EASTERN CORRIDOR SEGMENTS II AND III (PID 86462)

COMBINED LINWOOD/EASTERN INTERCHANGE & US 50/RED BANK INTERCHANGE FOCUS AREAS ADVISORY COMMITTEE MEETING NOTES

February 14, 2018
May 22, 2018
September 7, 2018
December 12, 2018

Figure X-3A-1
 ADDITIONAL RAMPS AT
 S.R. 125 AND U.S. 50 INTERCHANGE

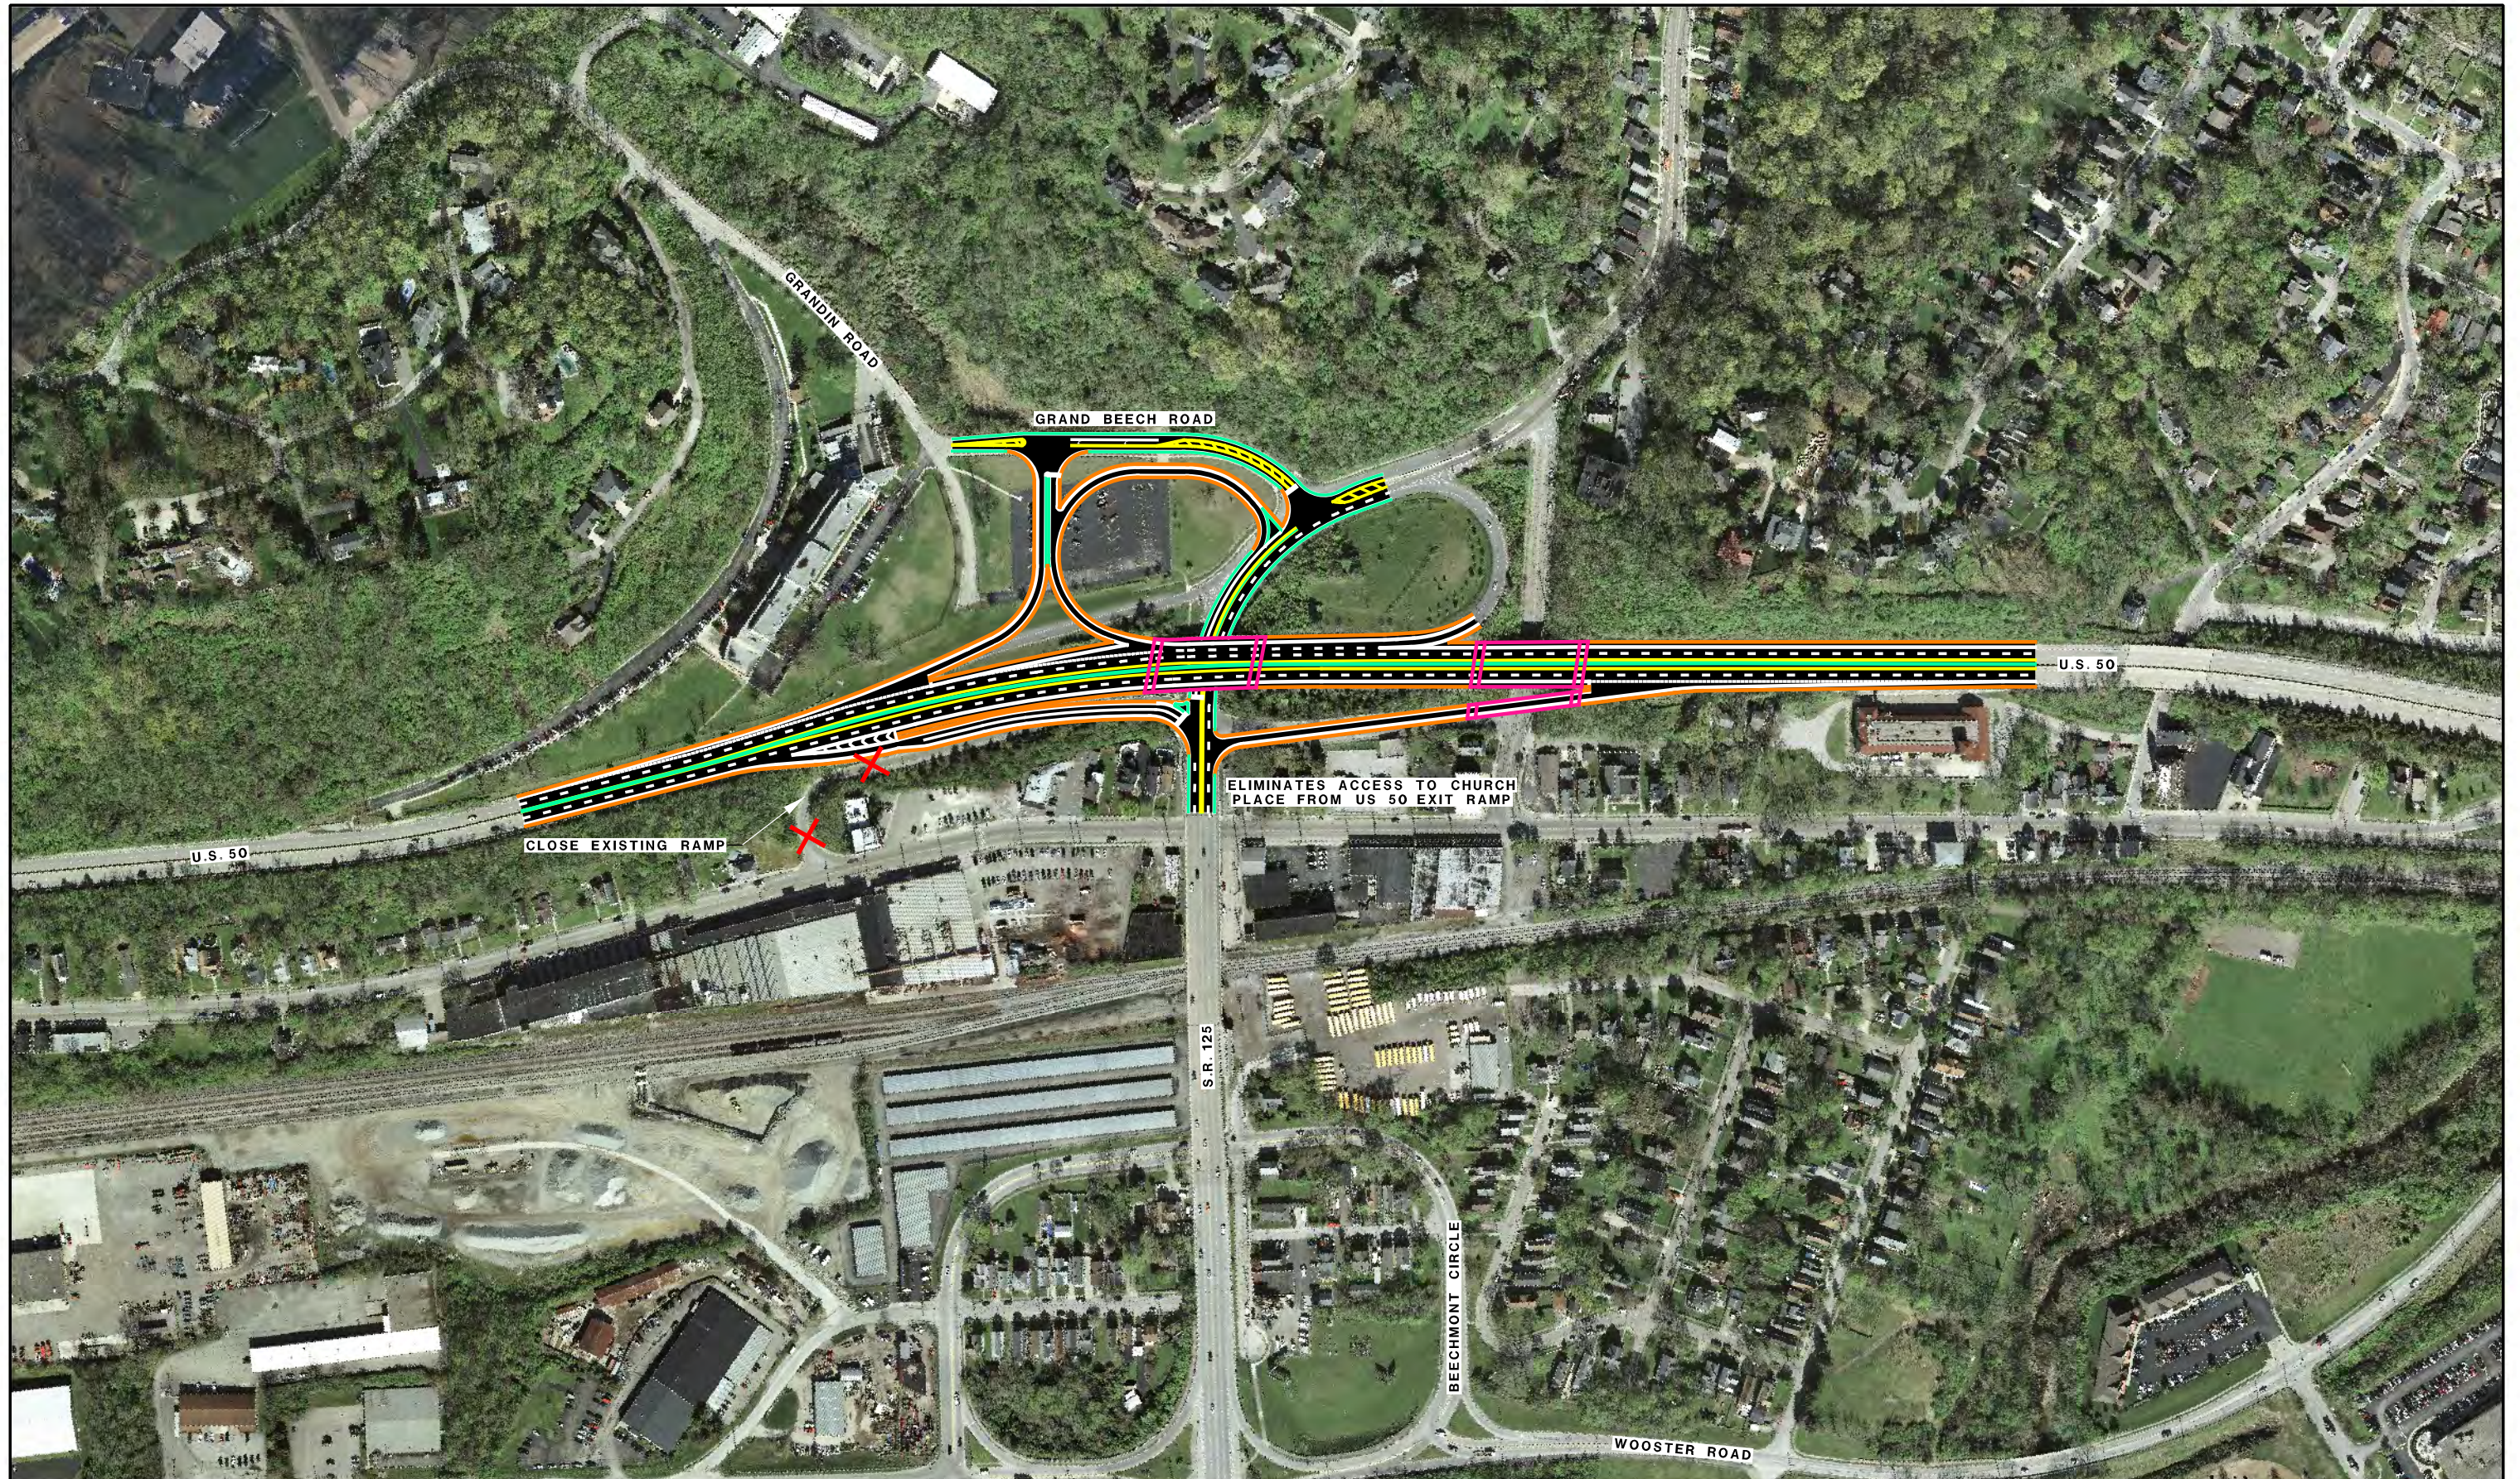
- No further study; concept X-3a-2 works better to improve traffic and safety operations.

RECOMMENDATION: NO FURTHER STUDY

Figure X-3A-2
 ADDITIONAL RAMPS AT
 S.R. 125 AND U.S. 50 INTERCHANGE

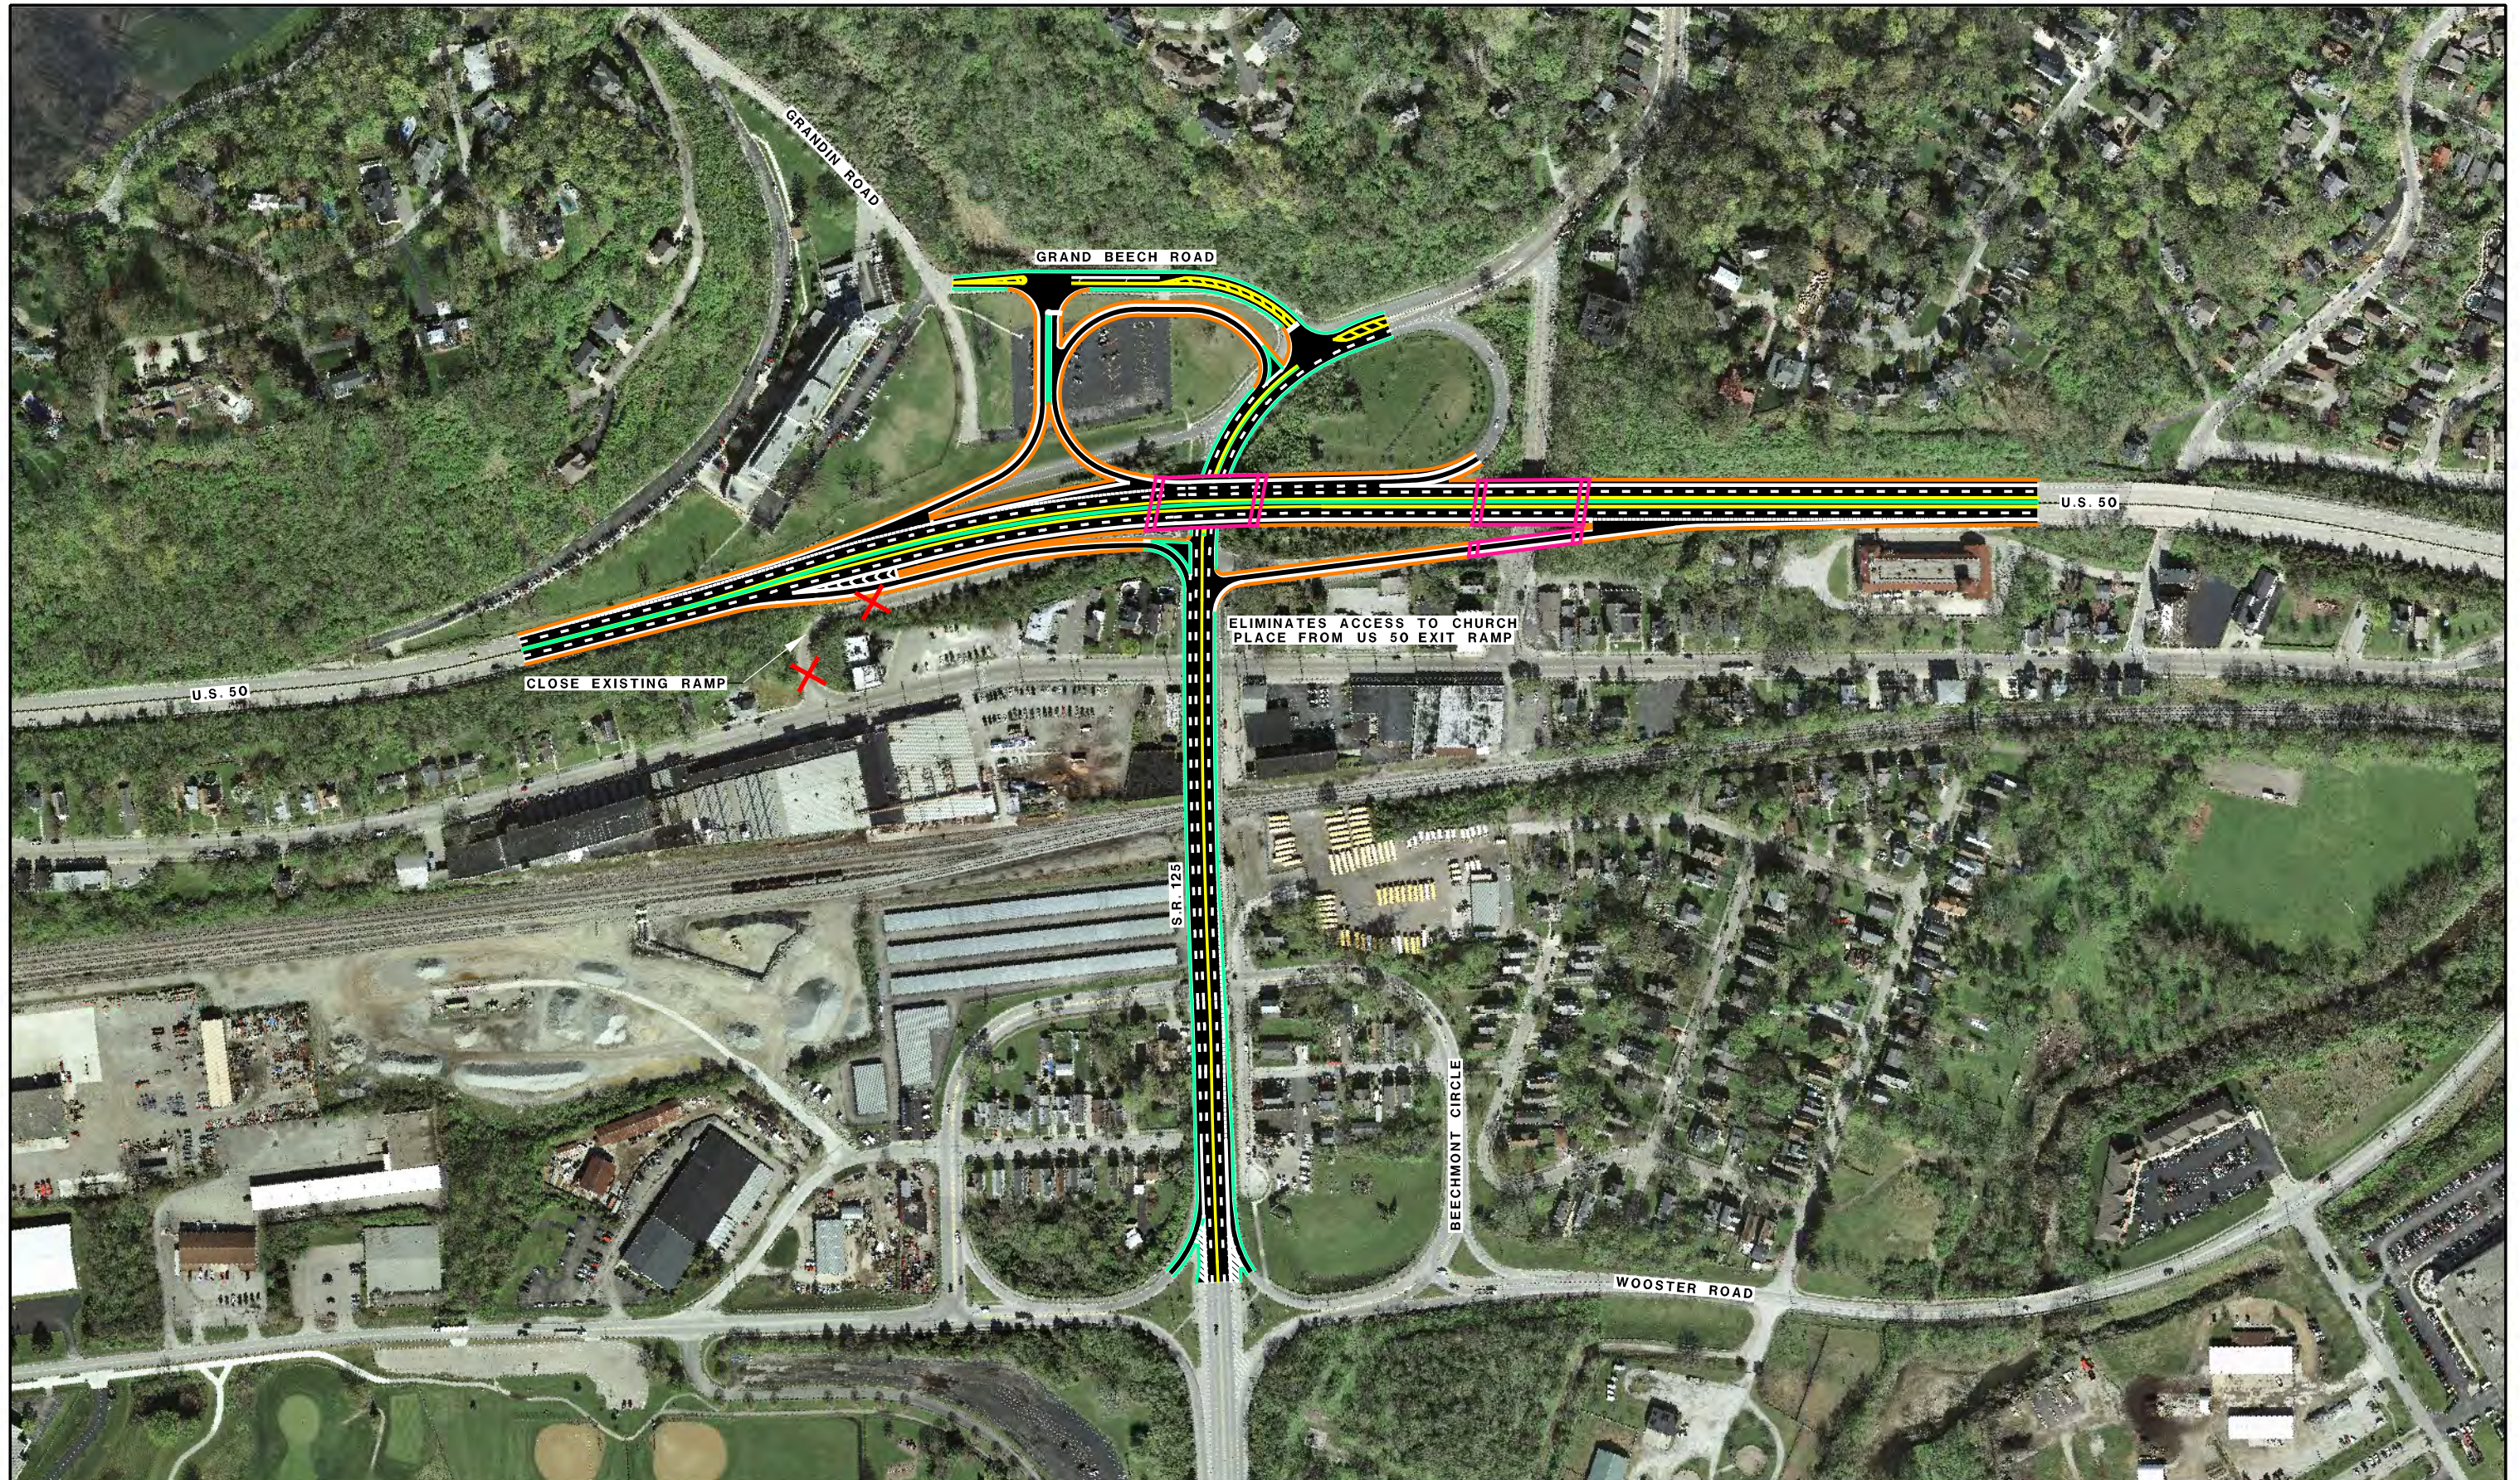
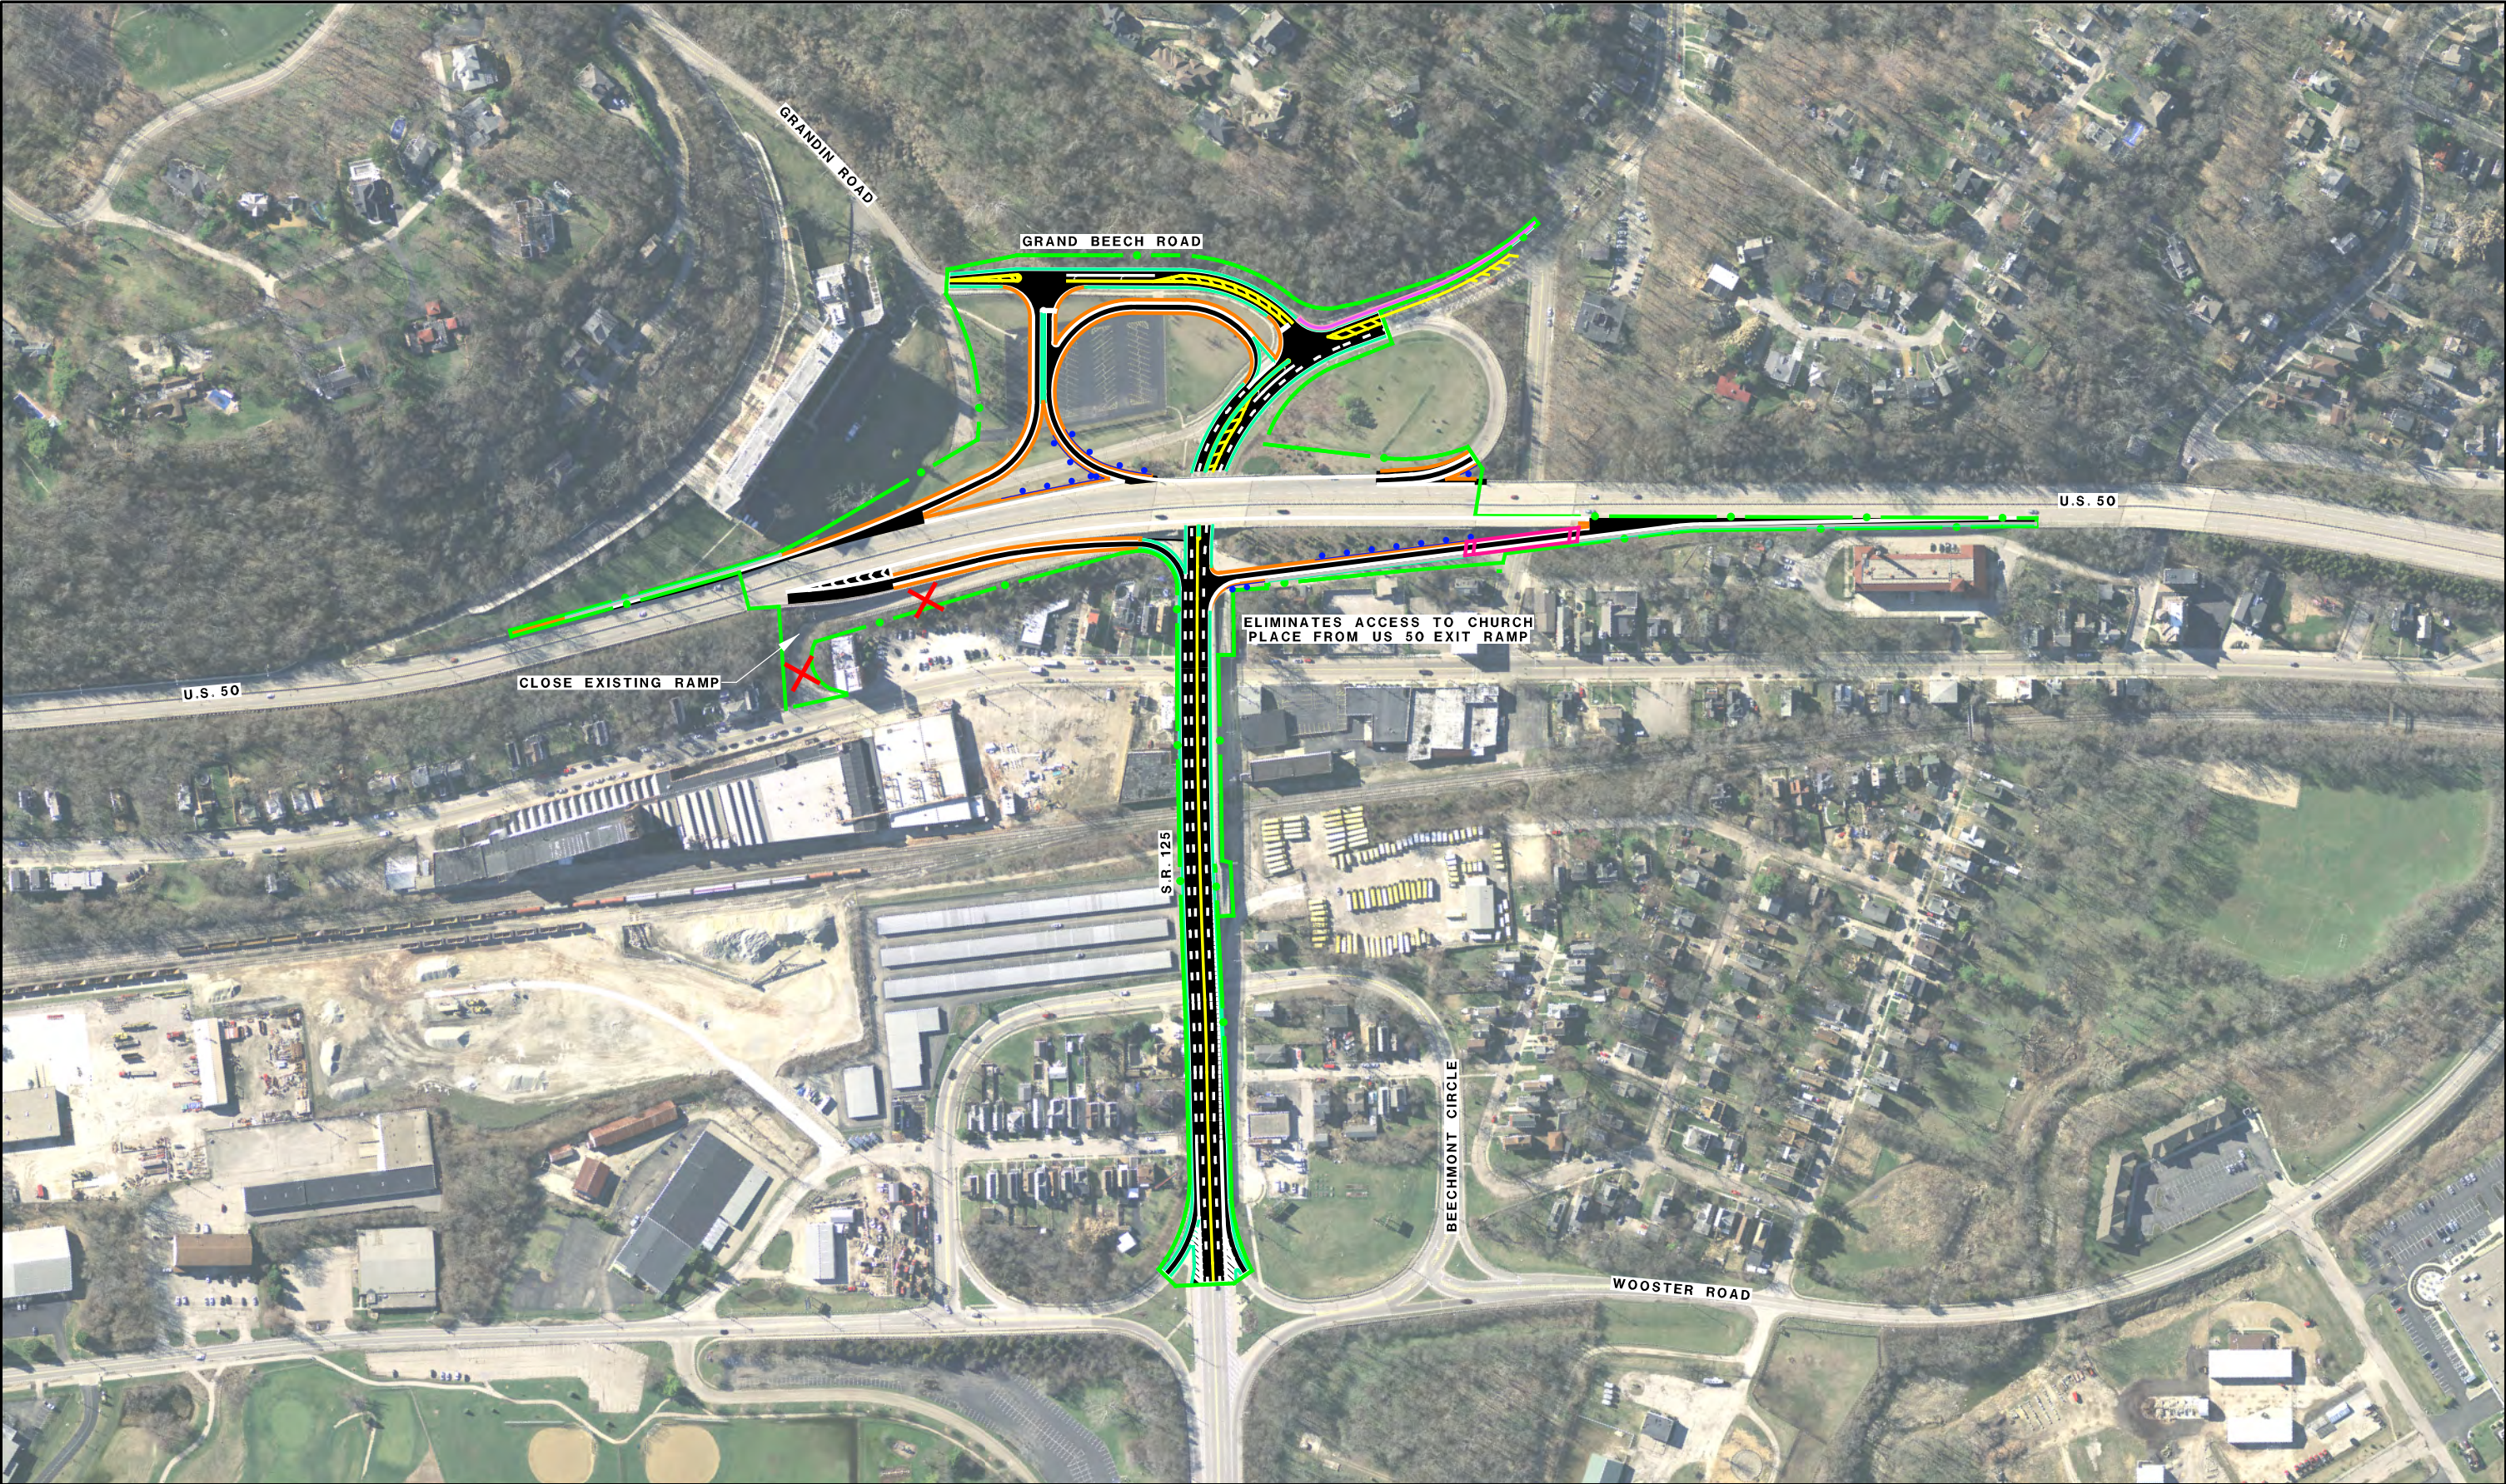
- Simulations show this concept would pull traffic off Wooster/Wilmer/Beechmont Circle without degrading operations on US 50; northbound and southbound travel speeds would increase during PM peak hours.
- The traffic benefit appears to be minimal compared to the expense; other alternatives offer similar traffic benefit for less cost.
- One Committee Member also expressed concern that this concept is detrimental to access within local communities with potential safety issues; drivers would need to use alternate routes that aren’t being improved.
- No additional comments received following the 9/7 meeting.

RECOMMENDATION: NO FURTHER STUDY
